FINAL GENERIC ENVIRONMENTAL IMPACT STATEMENT

ALBANY PORT DISTRICT COMMISSION PORT OF ALBANY EXPANSION PROJECT

TOWN OF BETHLEHEM, NEW YORK

FGEIS Acceptance Date: May 5, 2020

DRAWING NUMBER
FIGURE 2.3-1

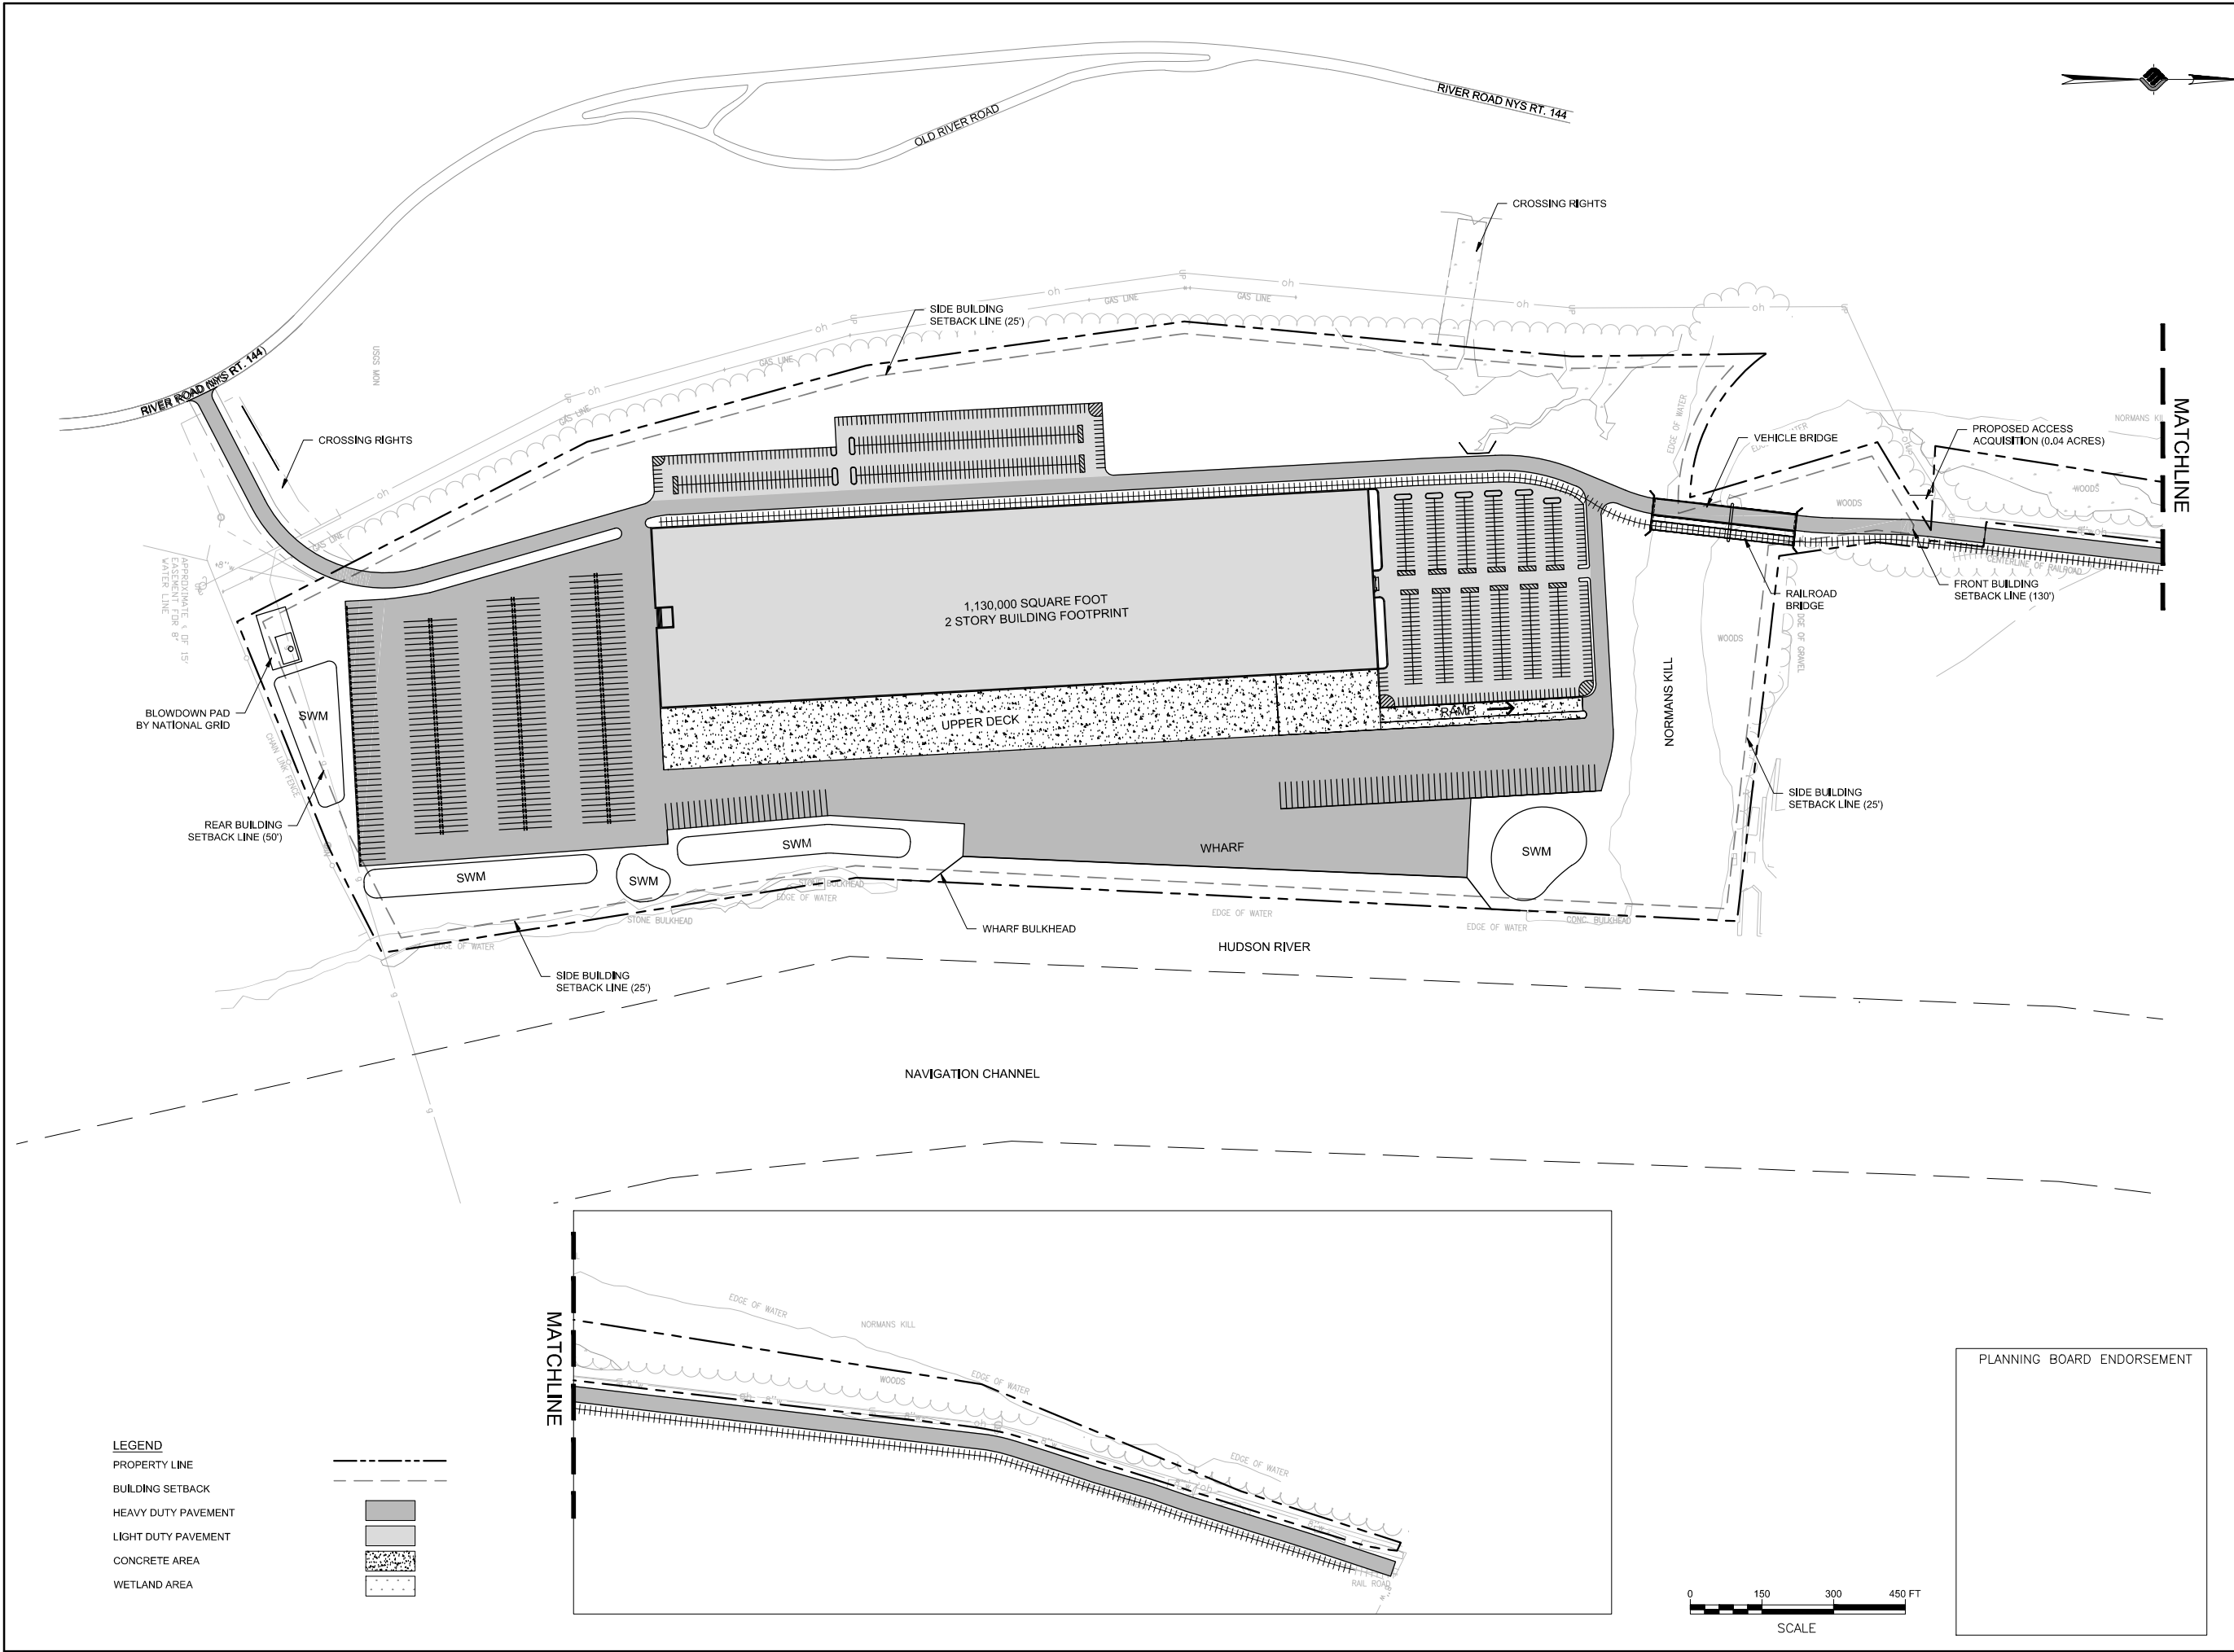
18. MJ ENGINEERING AND LAND SURVEYING, P.C.: The maximum development scenario directs the reader to Figure 2.3-1 to view this site concept. There should also be a reference to where the alternate site concepts can be viewed (Appendix O).

19. MJ ENGINEERING AND LAND SURVEYING, P.C.: Figure 2.3-1 should follow section 2.3-1.
RESPONSE: Figure 2.3-1 has been relocated to follow section 2.3. See Section 4.0 Updated Draft Generic Environmental Impact Statement Text Reflecting Public Comment.
20. MJ ENGINEERING AND LAND SURVEYING, P.C.: Identify the existing zoning designation for the site pursuant to the most current zoning map for the Town of Bethlehem. This would be suitable prior to the listed permitted use discussed in this section.
RESPONSE: Existing Zoning is Heavy Industrial and shall remain. See Section 4.0 Updated Draft Generic Environmental Impact Statement Text Reflecting Public Comment.
